DEPARTMENT OF
VETERANS AFFAIRS

MEMORANDUM

Subj: Radiation Shielding for Interventional Radiology Procedures Room

LOCATION DEPARTMENT OF VETERANS AFFAIRS VA MEDICAL CENTER DAYTON, OHIO	PROJECT TITLE PROPOSED RADIOLOGY BAYS	SHEET TITLE B-330 1ST FLOOR	DRAWN BY FCA	DATE 06/01/2018	SHEET 1 of 1
--	--	--------------------------------	-----------------	--------------------	-----------------

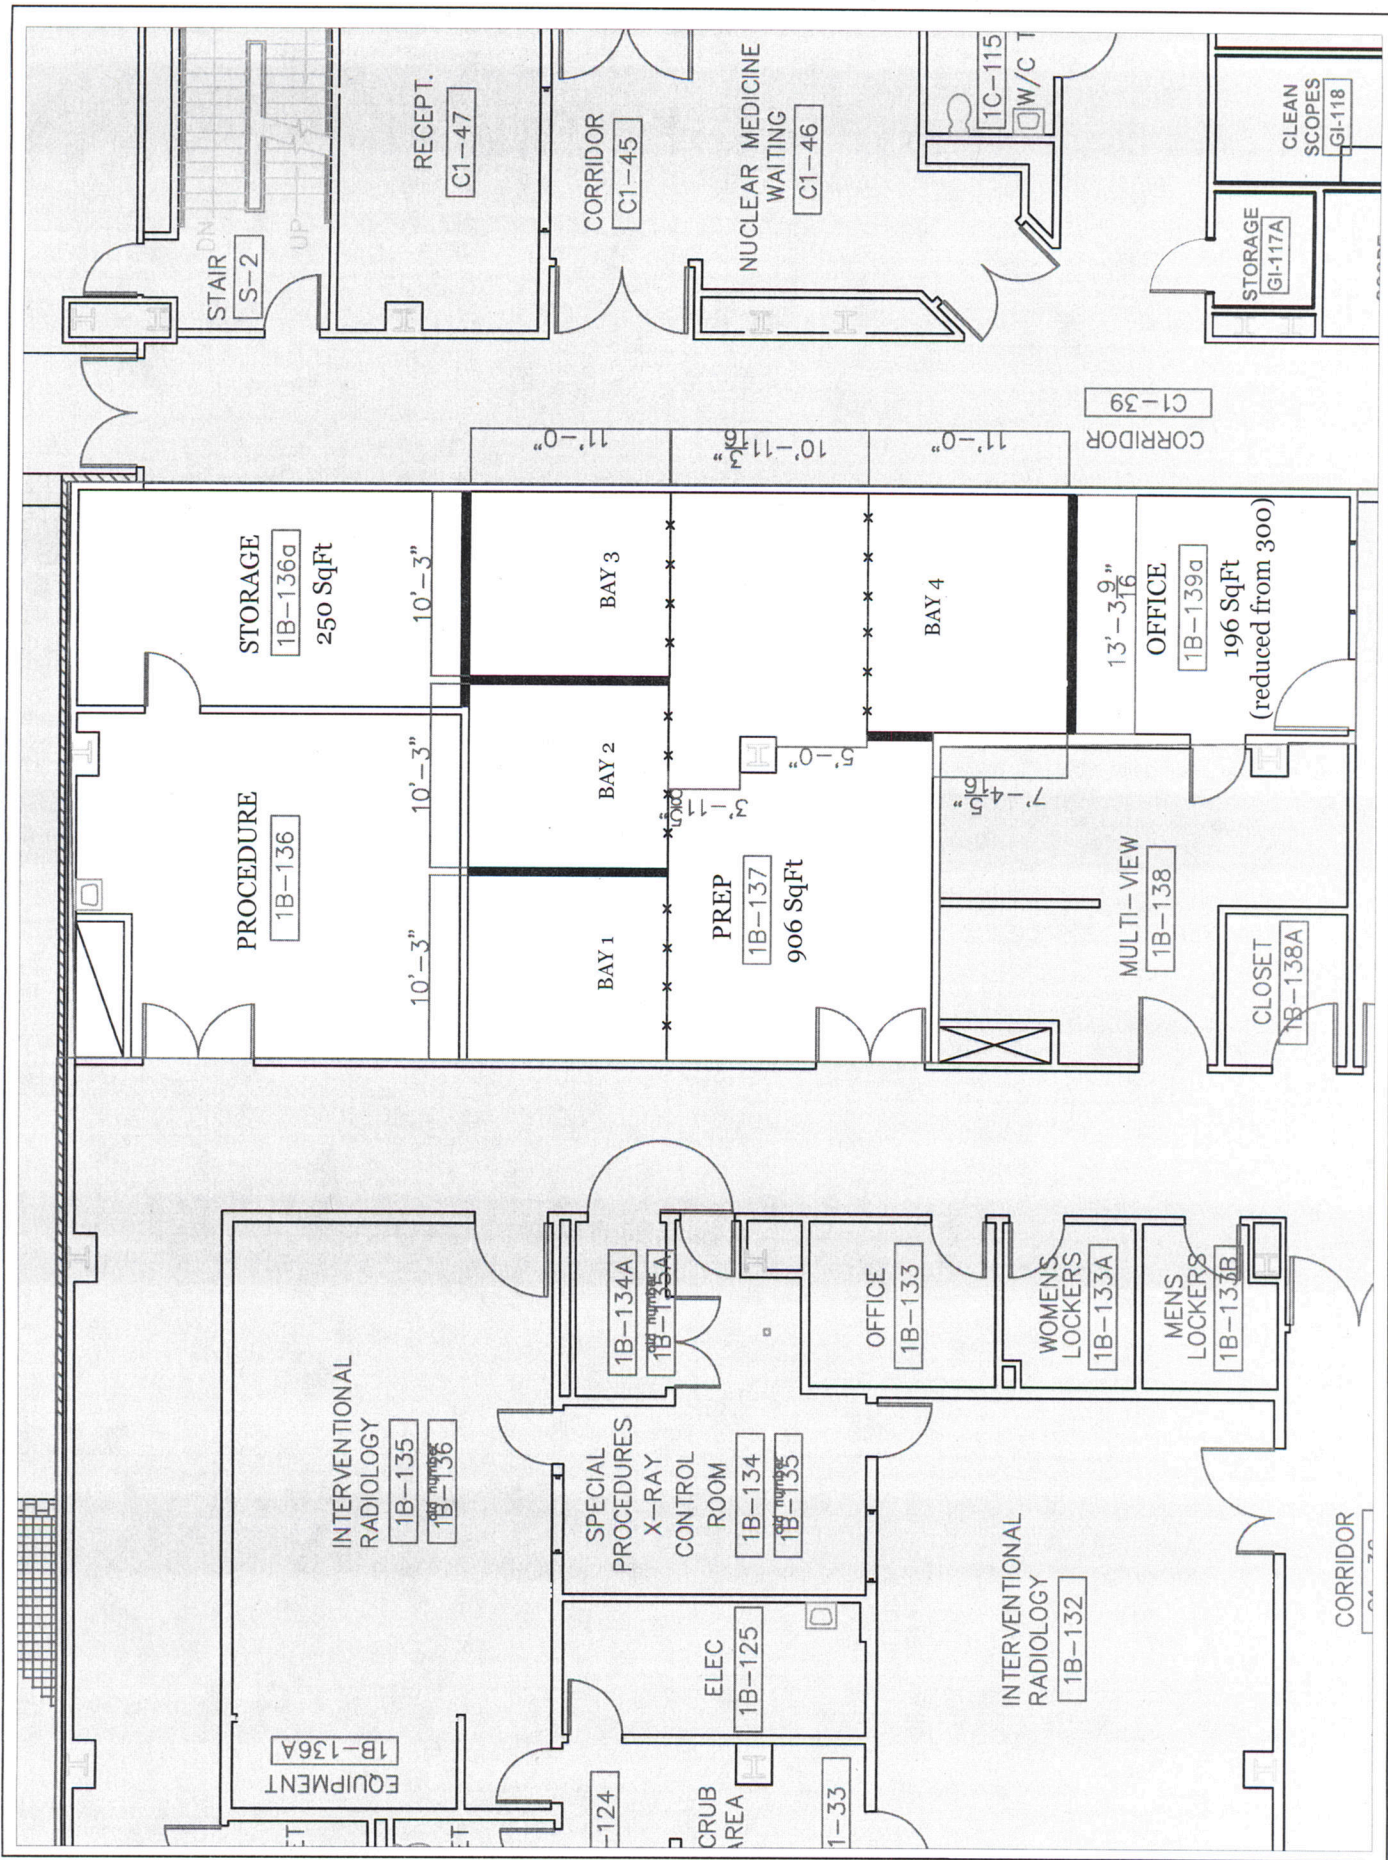
1. The purpose of this memorandum is to document shielding recommendations for a new procedure room to be constructed in 1B-136 of Building 330 at the Dayton VAMC. A mobile c-arm fluoroscopic unit will be utilized to perform various fluoroscopically-guided interventional procedures. Typically, these rooms are required to be shielded with the equivalent of at least 1/32-inch lead, including doors and windows. Floors and ceilings, if there is occupancy below or above, are normally required to also be equivalent to 1/32-inch lead or 2.5 inches of standard-density concrete (147 pounds per cubic foot). Calculation of barrier requirements is based on the methodology and data of NCRP Report No. 147 and estimated workload.

2. The estimated number of procedures per week is 50 for the new room. It is further assumed that the average fluoroscopy time per procedure is 3 minutes at 2 mA at 100 kVp. This translates into a weekly workload of 300 mA-min/week. According to Simpkin and Dixon (Health Physics, 68(5), 350-365, 1998) the unshielded secondary air kerma per mA-min at 1 meter from a beam of 1000 cm² at 100 kVp is equal to: 3.17E-2 mGy/mA-min for forward and back scatter and 9.9E-4 mGy/mA-min for leakage. Adjusting for field size (12-inch image intensifier) and source to image distance (36 inches), the scatter kerma is 2.77E-2 mGy/mA-min. The total secondary kerma is therefore equal to 2.87E-2 mGy/mA-min. Assuming the minimum distance from the fluoroscopy unit to a point any barrier is 1.5 meters, the unshielded air kerma is given by the product 300 mA-min/week and 2.87E-2 mGy/mA-min. This equals 3.83 mGy/week. The design goal is 0.02 mGy/week for uncontrolled areas if the occupancy is equal to 100%.

3. The required barrier transmission is equal to the ratio of the design goal to the unshielded air kerma and the occupancy factor (e.g., 0.02/3.83) which equals 0.0052 for 100% occupancy. This equates to a lead thickness of approximately 1.3 mm. None of the areas adjoining the procedure room have an occupancy of 100%. Using NCRP Report No. 147 recommendations regarding occupancy factors, the required barrier thickness is much less.

a. It is conservatively assumed that the occupancy in outdoor areas adjoining the procedure room is 2.5%. The required barrier transmission is equal to the ratio of the design goal to the unshielded air kerma and the occupancy factor (e.g., 0.02/3.83/0.025) which equals 0.2089. The required thickness of concrete is 16.41 mm.

b. It is conservatively assumed that the occupancy in patient holding and storage areas adjoining the procedure room is 5%. The required barrier transmission is

equal to the ratio of the design goal to the unshielded air kerma and the occupancy factor (e.g., $0.02/3.83/0.05$) which equals 0.1044. The required thickness of lead is 0.3 mm.

c. It is conservatively assumed that the occupancy in the corridor at the doors adjoining the procedure room is 12.5%. The required barrier transmission is equal to the ratio of the design goal to the unshielded air kerma and the occupancy factor (e.g., $0.02/3.83/0.125$) which equals 0.0418. The required thickness of lead is 0.54 mm.

d. It is conservatively assumed that the occupancy in the corridor adjoining the procedure room is 20%. The required barrier transmission is equal to the ratio of the design goal to the unshielded air kerma and the occupancy factor (e.g., $0.02/3.83/0.20$) which equals 0.0261. The required thickness of lead is 0.68 mm.

4. Based on these calculations, the recommended shielding is 1/32-inch (0.79 mm) leaded dry wall to a height of seven feet above the finished floor for all interior walls. The exterior wall does not require additional shielding. The door should contain 1/32-inch of lead. Please do not hesitate to contact me at william.ruckii@va.gov or X1511 if you have any questions.
